## ITC MAINTENANCE BUILDING ADDITION SITE PLAN 10-48

Consideration of the request of B Sarkett Construction for Preliminary Site Plan and Stormwater Management Plan approval. The subject property is located in Section 13 at 27175 Energy Way, south of Twelve Mile Road, between M-5 and Haggerty Road, in the OST, Planned Office Service Technology District. The subject property is approximately 59.3 acres and the applicant is proposing to add a 3,405 square foot single-story maintenance building addition to be connected to the existing ITC headquarters.

## PLAN REVIEW CENTER REPORT

**Engineering Review**  
ITC Maintenance Addition  
SP10-48

**SITE PLAN**

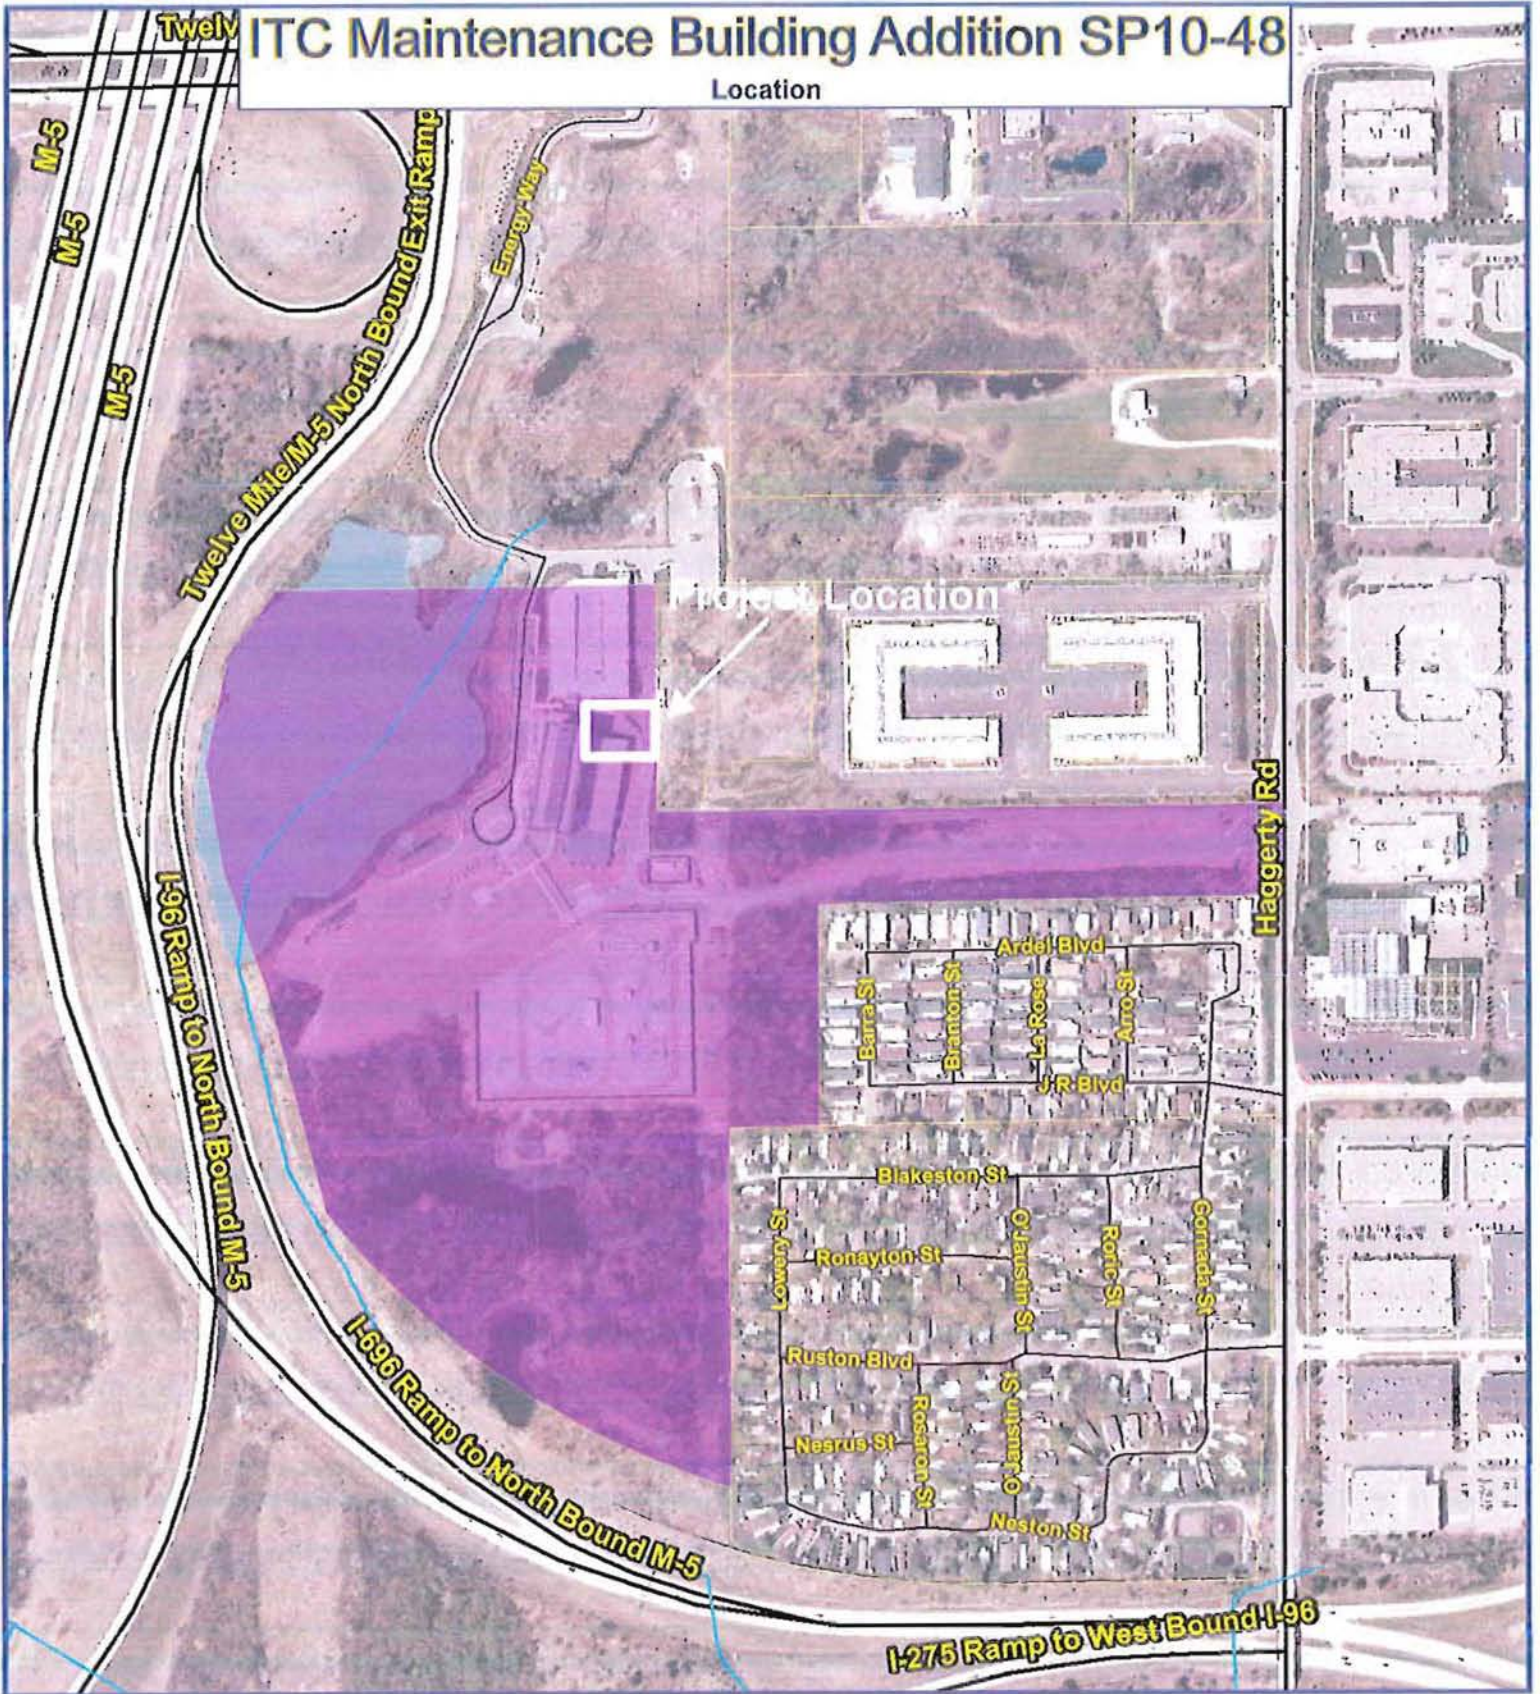
1. Planning Commission Approval: A building addition larger than 1,000 square feet and on a parcel of land adjacent to a residential zoning district requires the approval of the Planning Commission.
2. Landscape Plan: It appears landscaping will be removed to accommodate the proposed addition and new pavement. **The applicant should provide a landscape plan detailing the plantings to be removed and indicate if any landscaping will be installed around the new addition. This matter cannot proceed to the Planning Commission until a landscape plan is provided.** Additional review fees will apply.

5. Provide casting type and rim elevation for the proposed storm structure on the plan. Round castings shall be provided on all catch basins except curb inlet structures. Show that all drainage has a minimum of 1% slope toward the catch basin. Additional catch basins may be required.
6. Show and label all roof conductors, including diameter/material, and show where they tie into the storm sewer.

9. Provide spot elevations throughout the proposed paved surfaces. Show that all storm water runoff is accounted for.
10. Verify the slopes along the ingress/egress routing to the building from the barrier-free stalls comply with Michigan Barrier-Free regulations.
11. Curb and gutter is required surrounding the proposed parking area.
12. Curbing and walks adjacent to the end of 17-foot stalls shall be reduced to 4-inches high, rather than the standard 6-inch height to be provided adjacent to 19-foot stalls. The current plan shows a 4-inch integral curb with 19-foot stalls. If the sidewalk is widened to 7-feet, the adjacent parking stalls can be reduced to 17-feet in length with a 2-foot overhang. All other curb shall be the minimal 6-inches high.
13. Provide top of curb/walk and pavement/gutter grades to indicate height of curb adjacent to parking stalls or drive areas.

14. A curbed end island is required adjacent to the northern most parking stall. The end island shall conform to the City standard island design, or variations of the standard design, while still conforming to the standards given in Section 2506 of Appendix A of the Zoning ordinance (i.e. 2' minor radius, 15' major radius, minimum 8' wide, 3' shorter than adjacent 19' stall).

15. The standard Type 'M' approach is required at any approach conveying storm water. This appears to be the case at the proposed approach shown on the plan. Provide proper entrance radii and show the approach does not conflict with the current retaining wall.

16. Show all proposed ramps and ramp details on the plan and show that each ramp meets ADA requirements.
17. Label the existing retaining wall elevations. A fence maybe required along the retaining wall.

The facade review for the original building was based on the accents bands being constructed of Limestone. The accent bands on the proposed addition are identified as "New Precast Band to Match Existing." Precast Concrete is not an allowed material whereas limestone is allowed up to 100%. It is assumed the new accent band will match the existing in all respects.

*Item #11. Curb and gutter is required surrounding the proposed parking area. We currently have an integral curb/walk in this area with pavement providing positive drainage to existing catch basins.*
